**TOWN OF NEWBURGH
PLANNING BOARD
TECHNICAL REVIEW COMMENTS**

PROJECT: JKS, LLC
PROJECT NO.: 15-21
PROJECT LOCATION: SECTION 10, BLOCK 7, LOT 1
REVIEW DATE: 14 AUGUST 2015
MEETING DATE: 20 AUGUST 2015
PROJECT REPRESENTATIVE: TALCOTT ENGINEERING

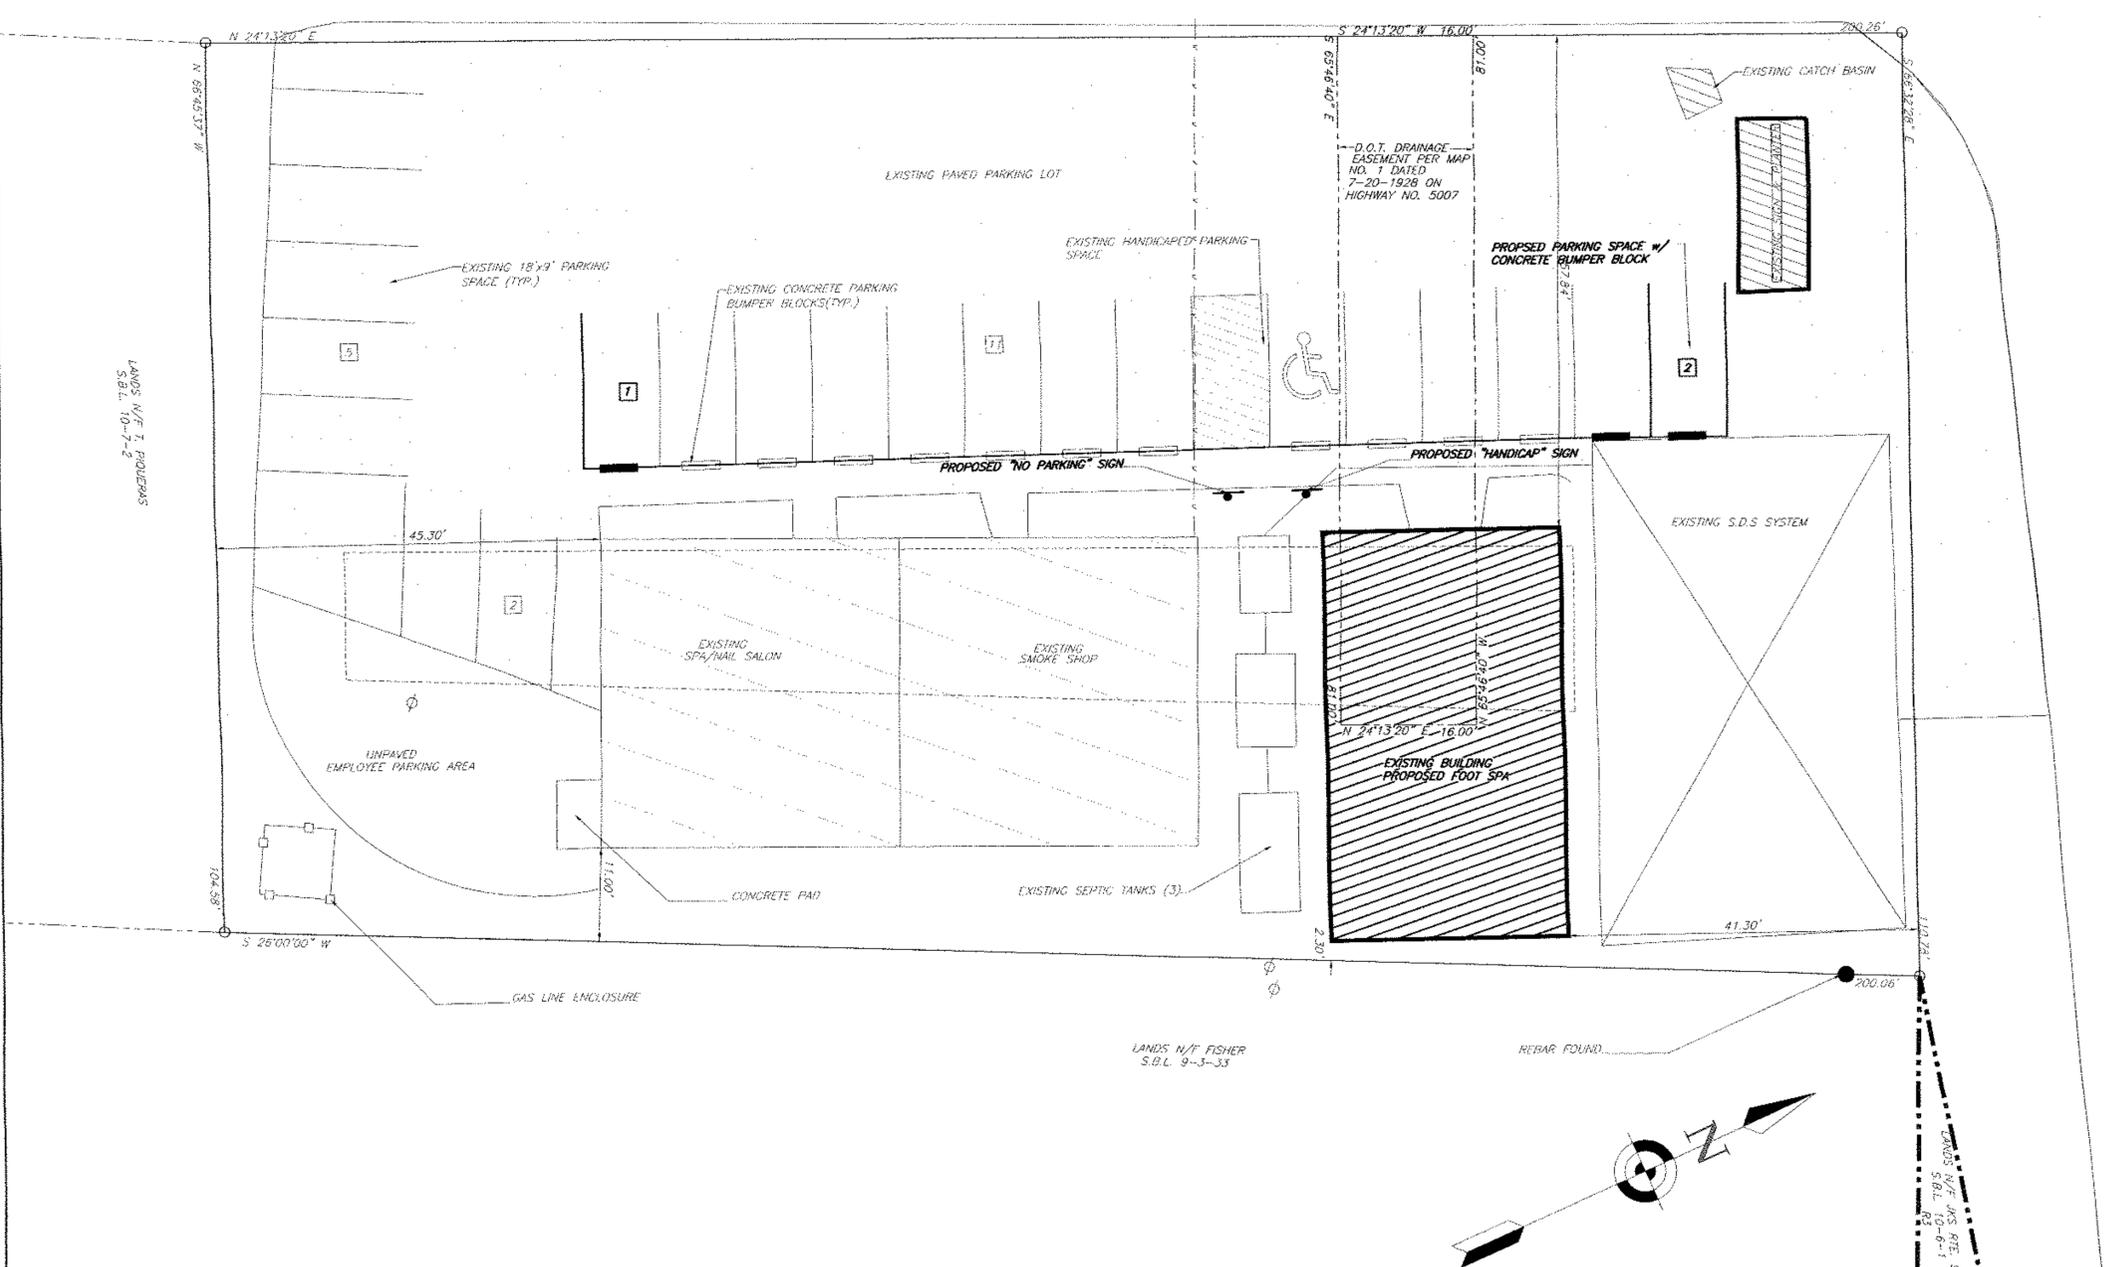
1. Project requires referral to Zoning Board of Appeals as existing structure does not meet front yard and rear yard setbacks.
2. Information pertaining to the existing Subsurface Sanitary Sewer Disposal System should be provided. System appears to be a repaired fill system. Water flow from the site should be determined in the existing and proposed uses.

3. The Planning Board should discuss whether project is to be submitted to NYSDOT for review. Currently uncontrolled access from the entire property frontage exists on the site.

4. Planning Board should review existing landscaping and site condition with regard to compliance with Town of Newburgh Design Guidelines. Plans should depict adjoining building to the south which is very close to property line.

5. Dimension all lane widths between parking spaces that does not appear adequate space exists between the proposed new #1 parking space and the 5 parking spaces along the south property line.

6. The area delineated as unpaved employee parking area appears to be a vegetative surface in recent aerial photos.
7. Plans should address any waste disposal enclosures existing, or proposed on the site.

8. Existing signage does not appear to be in compliance with the 15 foot required setbacks. Additional variance may be required.

9. The Applicants are requested to address the DOT easement which appears to run through the building proposed for the change of use.
10. Parking calculations are based on the 3.125 square feet building, outside dimensions total 4,044 square feet. This should be further clarified if interior leased areas are different. Floor plans should be provided documenting total leasable space.
